JAMES GULLOBY ARCHITECT, LLC

ADDENDUM NO. 1

PROJECT: Addition To Classroom Building
Bunkie High School – Bunkie, Louisiana
Avoyelles Parish School Board
Marksville, Louisiana

PURPOSE: Clarification of Documents

A102

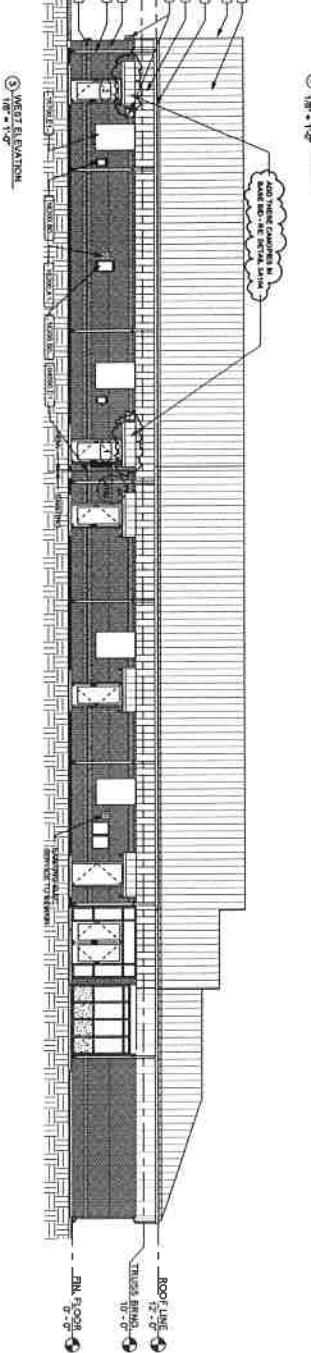
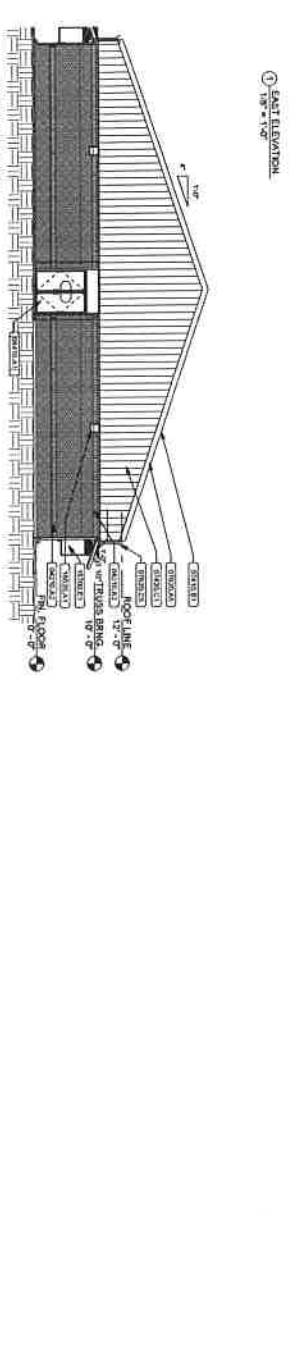
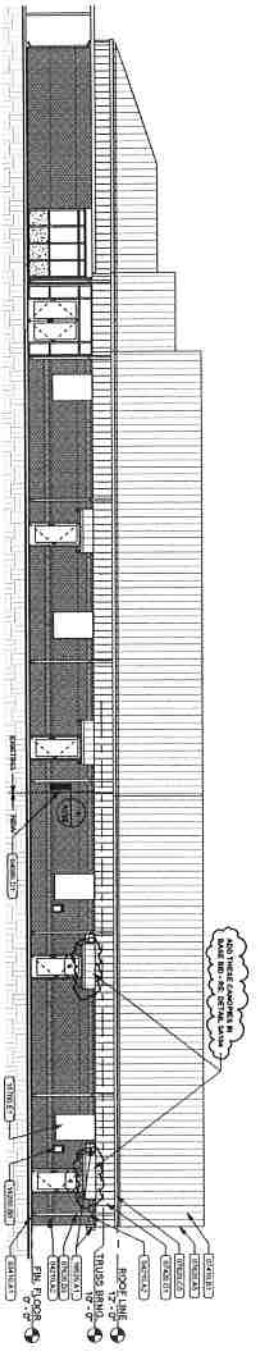
SHEET A102 – EXTERIOR ELEVATIONS: Add metal canopy roofs above exterior doors 1, 2, 4 & 5 required in the base bid. Refer to Revised Sheet A102 attached at the end of this document as well as revisions at 3A104 for details.

DATE: 11-27-2021
 DRAWING: WALL SECTIONS

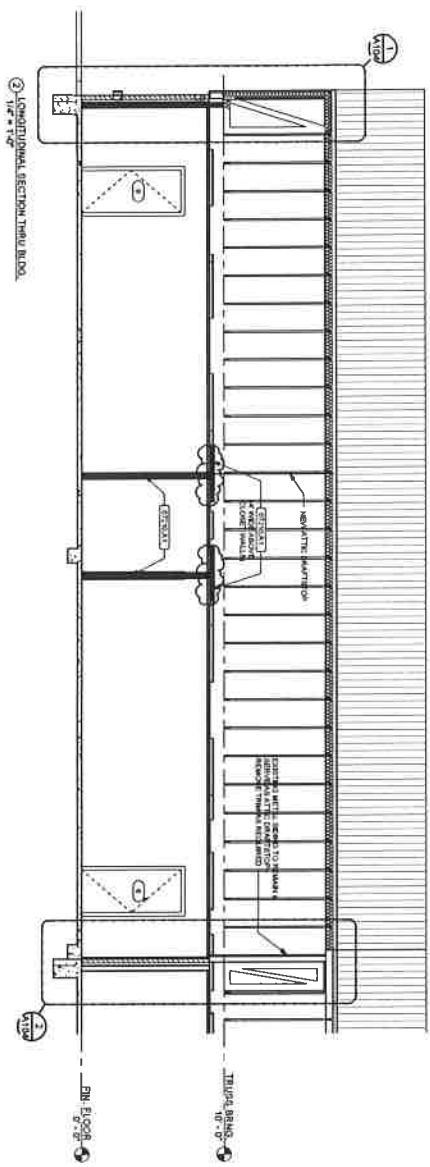
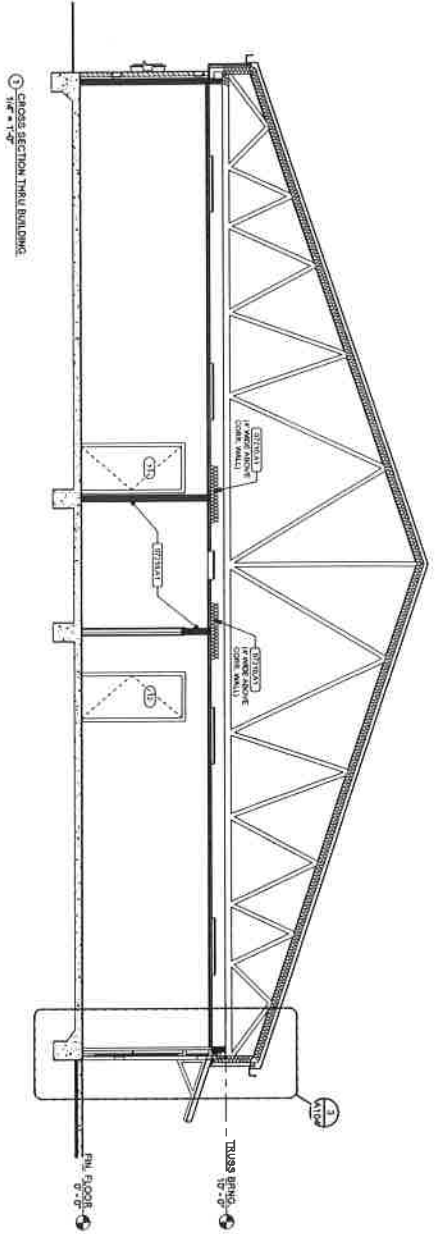
SHEET A104 – WALL SECTIONS: Refer to Revised Section 3 for details of metal canopy roofs required in the base bid. Refer to revised SHEET A104 attached at the end of this document.

SHEET A104 – WALL SECTIONS: Add batt insulation supports for all 6" R-19 unfaced batt insulation (Re: Keynote 07210.A4) applied at the bottom of the roof deck. At the Contractor's option;

1. Install 14 ga. Wire insulation supports such as Simpson Strong-Tie, Tiger Teeth or approved equal.
2. Install 2"x20 Ga. poultry wire nailed or stapled to bottom of roof trusses.

A103

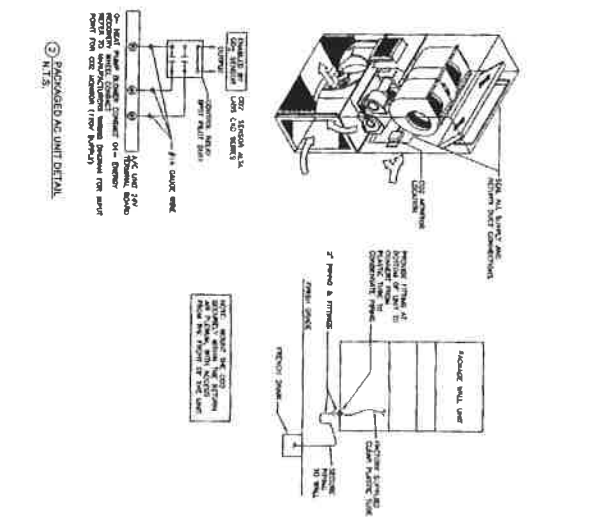
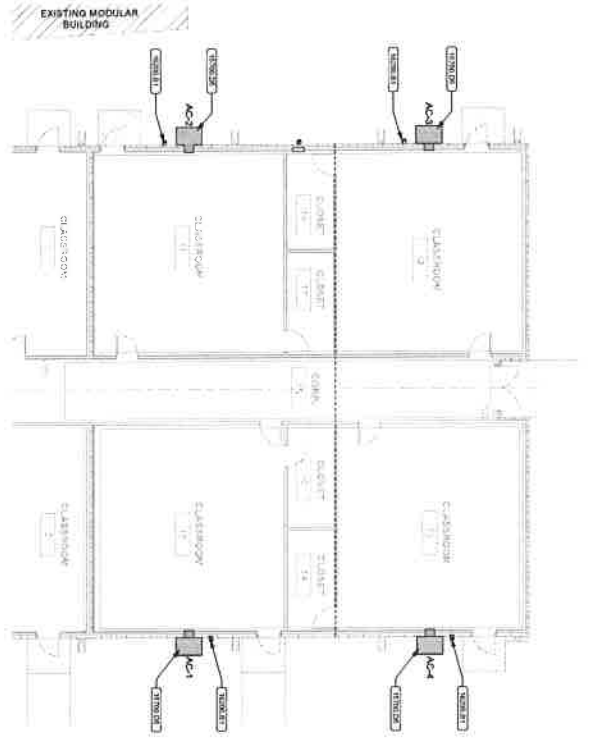
SHEET A103 – BUILDING SECTIONS:

Refer to Revised Cross Section Thru Building and change Keynote 07210.A1 to 07210.A2. Refer to Revised Longitudinal Section Thru Building and add 3 ½" unfaced batt insulation (4' wide strip) above the closet wall. Refer to revised Sheet A103 attached at the end of this document.
